Coal Combustion Residue Impoundment Round 9 - Dam Assessment Report

Miller Steam Plant

Coal Combustion Residue Impoundment Dike Alabama Power Company West Jefferson, Alabama

Figure 5.2.3-5 Wet Area Outside Slope of Main Dam Toe

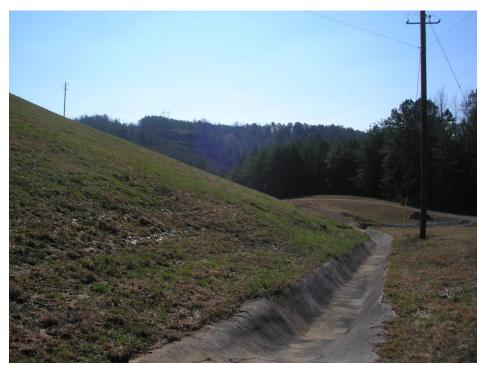
A few isolated wet areas were observed near the outside toe of the dam (see Figure 5.2.3-5). No evidence of flowing water was observed. It could not be determined if the source of water was minor seepage through the embankment or residual precipitation from recent storms.

Photo 8: Debris in Concrete Lined Drainage Ditch Along Saddle Dam Toe

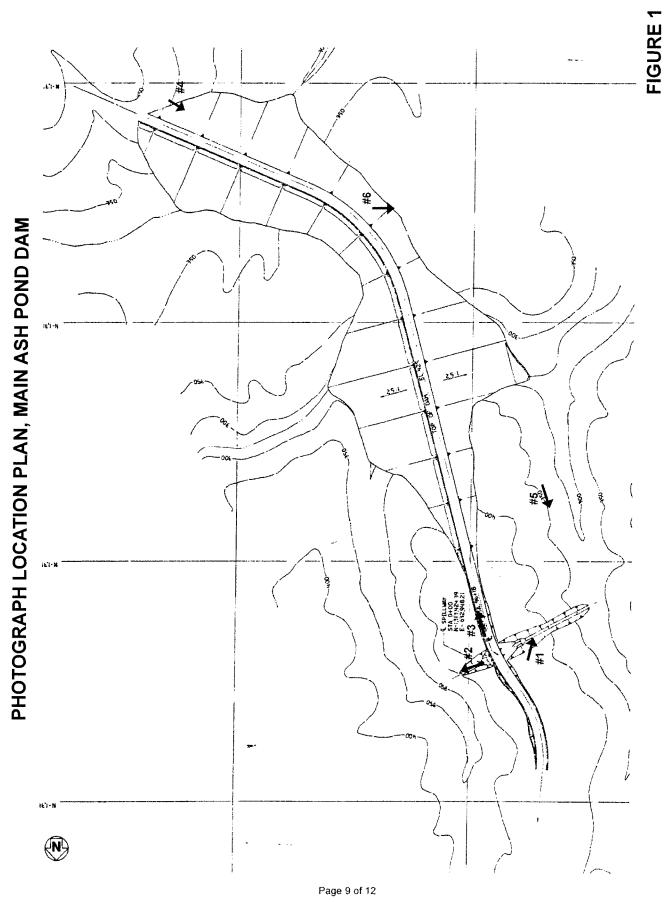
A portion of the concrete-lined drainage ditch had become clogged with debris (see Photo #8). As discussed above, it is recommended that the plant clear the debris from the drainage ditch so that it flows freely. It should be noted that this is not an urgent concern, but is suggested as a best practice.
